Robert L. Campbell Structural Engineer, P.C.

January 28, 2022

Re: City of Somerton 1.0M Gallon Water Tank – Structural Review

Roof purlin
connection
to steel
beam

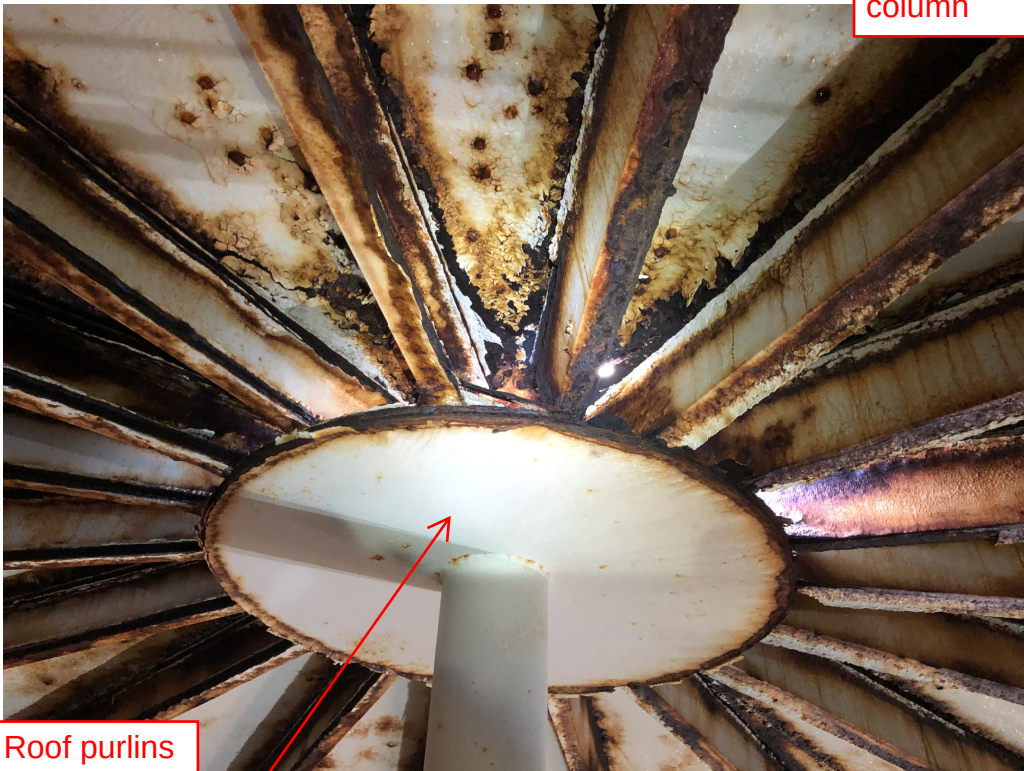
- Tank Roof and Columns:
 - The observed corrosion on the steel roof plate, steel channel rafters and wide flange beams has progressed to the extent of causing failure of the roof structure. In several locations, the steel channel rafters have failed and are dangling from one end, flanges on all channel rafters and wide flange beams are corroded to the point of delamination.

1. The roof structure shall be replaced in its entirety. This includes roof plate, rafters and beams.
2. The steel pipe columns, base plates and top of column plates shall be replaced.

Roof beam
to top of
steel pipe
column

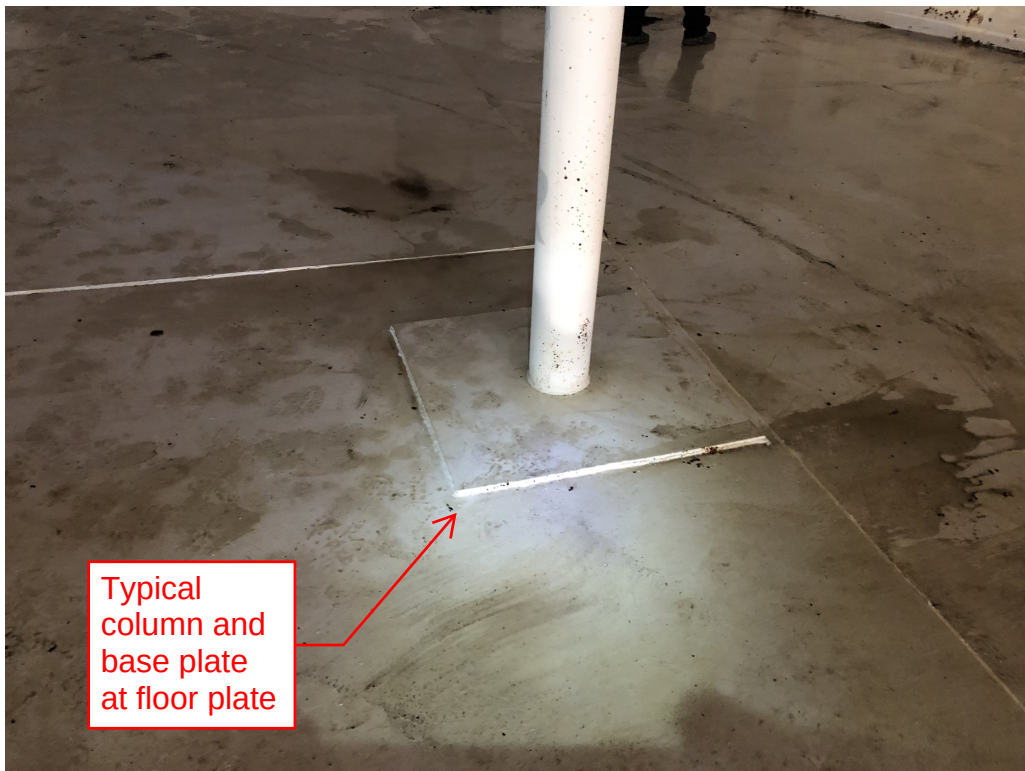
- The steel bearing plate at the top of columns, which supports the wide flange beams, is corroded with delamination.
 - Similar to the outer steel shell, the interior pipe columns are corroded at the normal operating water elevation.
